STAFFORD LOGISTICS CENTER SUBDIVISION FILING NO. 5

SITE PLAN

STAFFORD LOGISTICS CENTER SUBDIVISION FILING NO. 5
SITE PLAN COVER SHEET
AURORA, CO

SHEET
C3
3

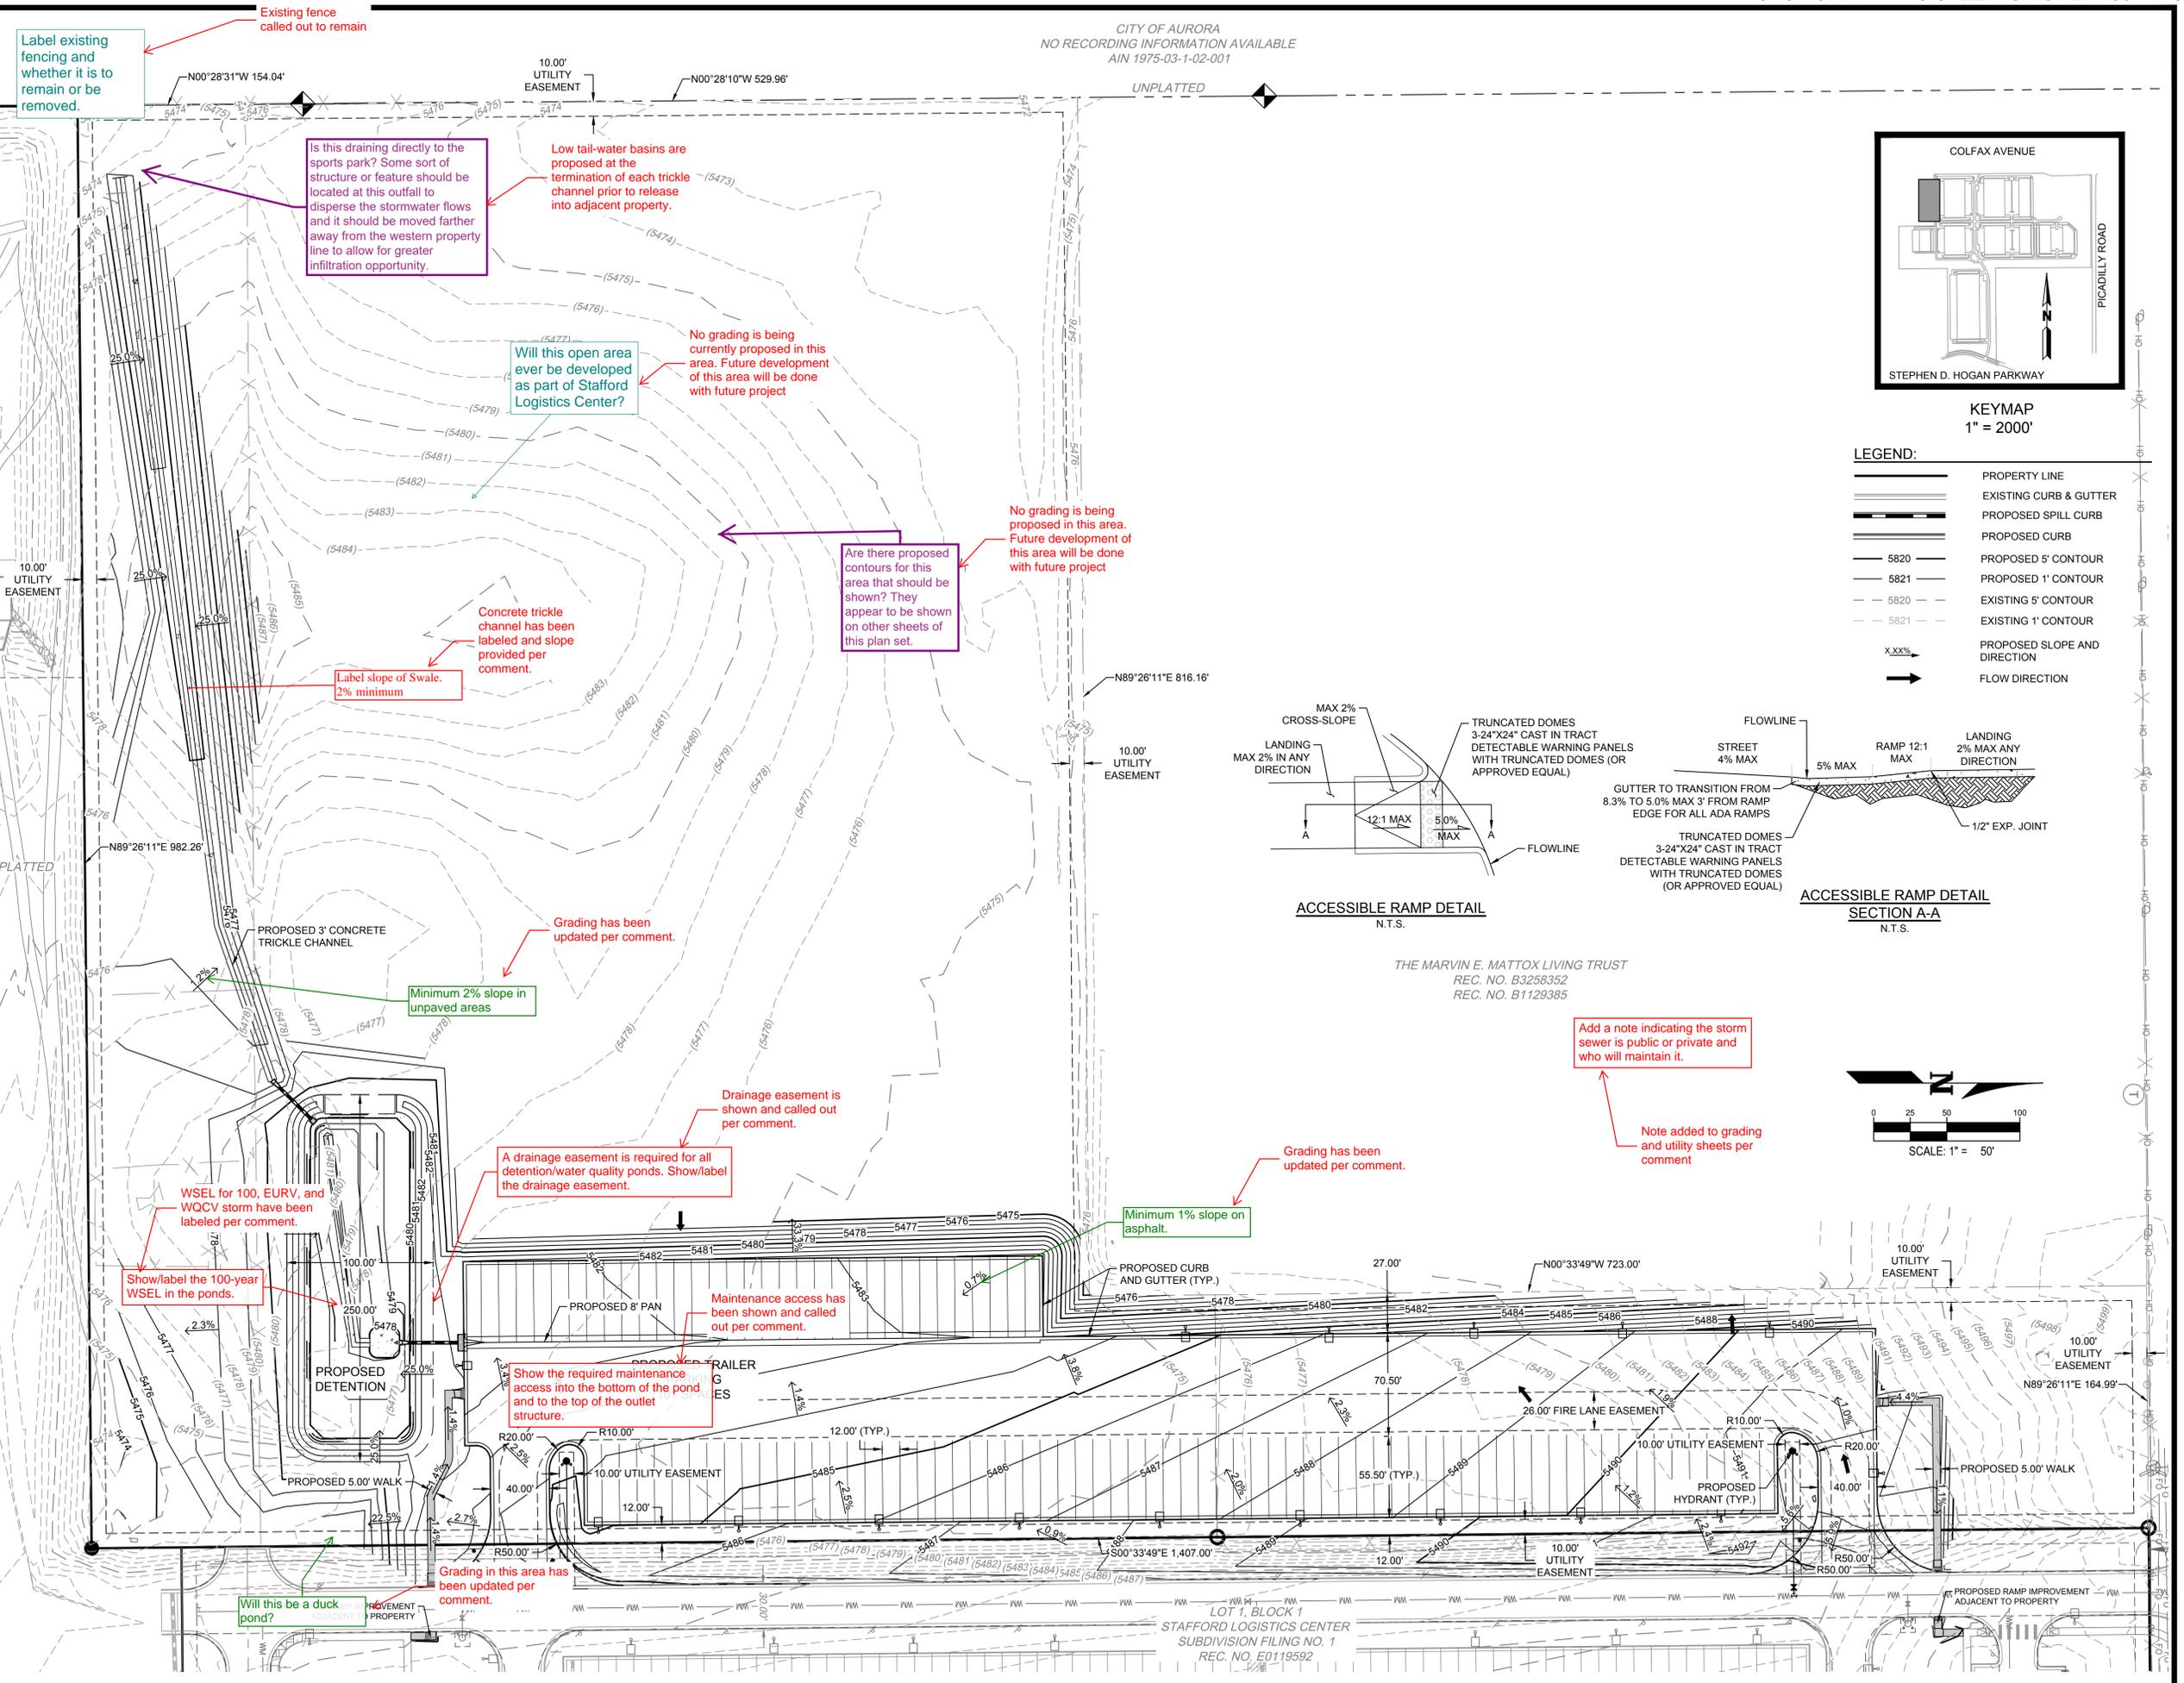
Label existing fencing and whether it is to remain or be removed.

Is this draining directly to the sports park? Some sort of structure or feature should be located at this outfall to disperse the stormwater flows and it should be moved farther away from the western property line to allow for greater infiltration opportunity.

Will this open area ever be developed as part of Stafford Logistics Center?

Are there proposed contours for this area that should be shown? They appear to be shown on other sheets of this plan set.

Label slope of Swale. 2% minimum

Minimum 2% slope in unpaved areas

A drainage easement is required for all detention/water quality ponds. Show/label the drainage easement.

Minimum 1% slope on asphalt.

Add a note indicating the storm sewer is public or private and who will maintain it.

Show/label the 100-year WSEL in the ponds.

Show the required maintenance access into the bottom of the pond and to the top of the outlet structure.

Will this be a duck pond?

Existing fence called out to remain

Low tail-water basins are proposed at the termination of each trickle channel prior to release into adjacent property.

No grading is being currently proposed in this area. Future development of this area will be done with future project

No grading is being currently proposed in this area. Future development of this area will be done with future project

Concrete trickle channel has been labeled and slope provided per comment.

Grading has been updated per comment.

Drainage easement is shown and called out per comment.

Grading has been updated per comment.

Note added to grading and utility sheets per comment

WSEL for 100, EURV, and WQCV storm have been labeled per comment.

Maintenance access has been shown and called out per comment.

Grading in this area has been updated per comment.

1 PHOTOMETRIC SITE PLAN
 E0.0 SCALE: 1" = 50'

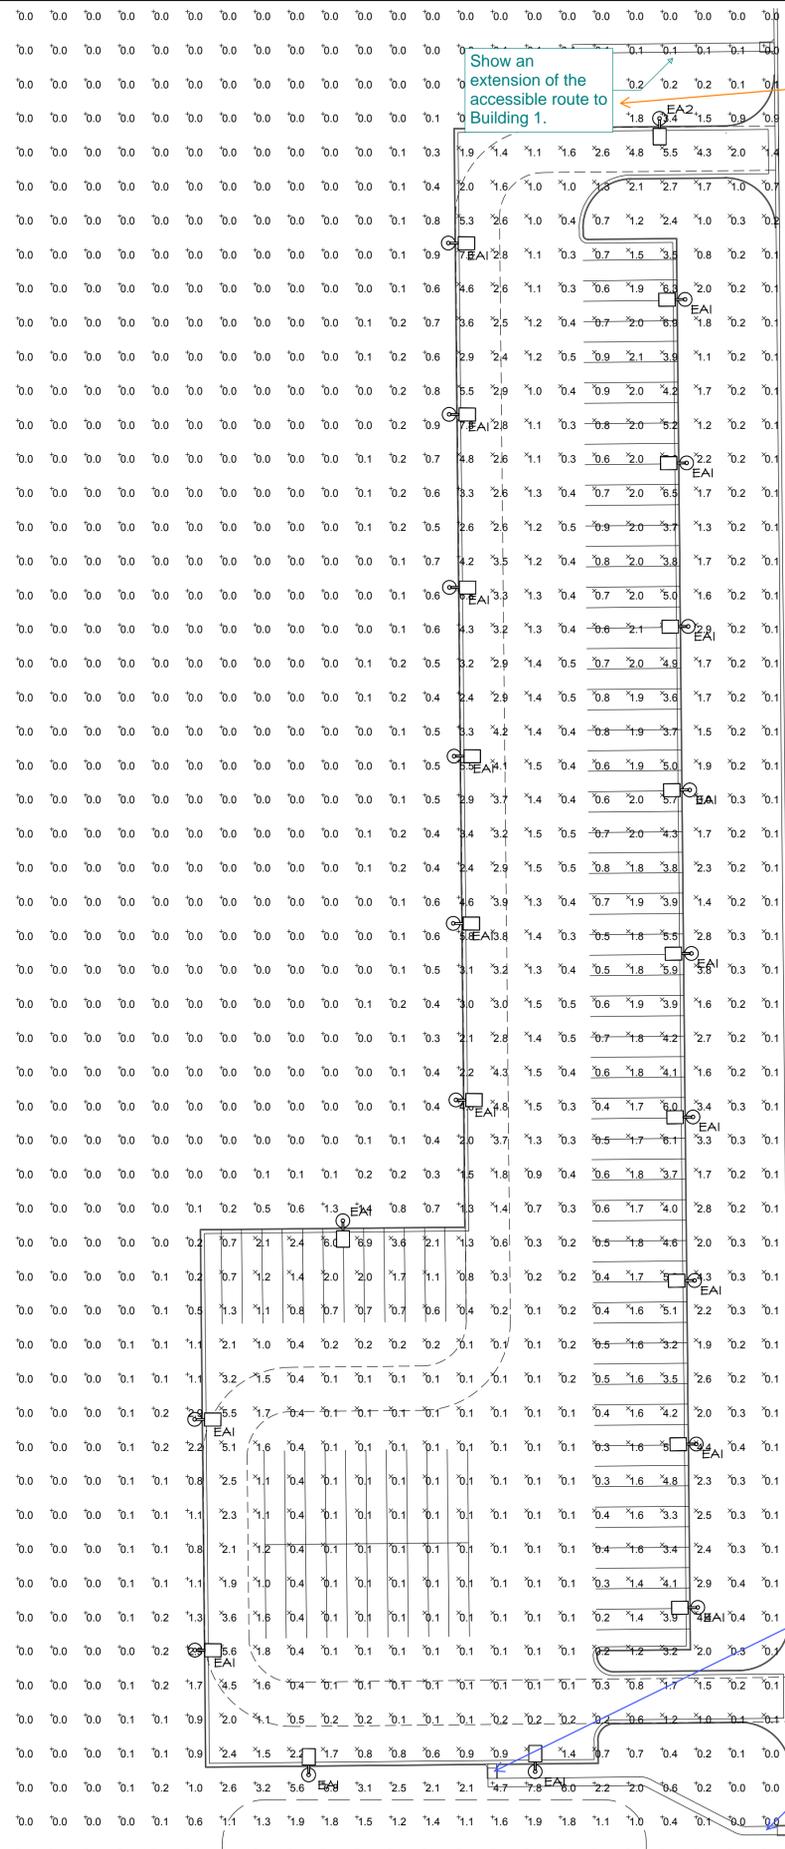
Show an extension of the accessible route to Building 1.

Using a heavy dashed delineation and label show the exterior accessible route of travel throughout the site plan to:

- Public transportation stops.
- Accessible parking and accessible passenger loading zones. This includes required accessible garages.
- 60% of the required building entrances. Indicate all entrances and required exits on the plan.
- Provide an accessible route to all on site amenities. These elements can include, but are not limited to; tennis courts, club houses, pools, laundry facilities, mail kiosks and dumpsters.
- Curb ramps at street crossings and where accessible parking space access aisles connect to adjacent sidewalks.
- Provide marked crosswalks in all areas where the accessible route crosses a drive aisle.
- Accessible routes must be shown passing through gated entry(s) served.
- Show and label the location of accessible units required by IBC Chapter 11 and 2003 HB-1221 to be part of the exterior accessible route.

If this is designated an Accessible Route, delineate with a heavy dashed line and ensure the route is illuminated per the graphic provided.

The photometric plan must show and label the location of the internal site accessible route. Provide a minimum of 1 foot-candle of lighting within the accessible route.

Where an accessible route crosses a drive-aisle provide curb ramps and crosswalk.

AE Design Response: This walk is not to be designated as an accessible route and therefor will not be labeled as noted and will not be illuminated to minimum of 1 footcandle.

AE Design Response: This walk is not to be designated as an accessible route and therefor will not be labeled as noted and will not be illuminated to minimum of 1 footcandle.

AE Design Response: This walk is not to be designated as an accessible route and therefor will not be labeled as noted and will not be illuminated to minimum of 1 footcandle.

AE Design Response: This walk is not to be designated as an accessible route and therefor will not be labeled as noted and will not be illuminated to minimum of 1 footcandle.
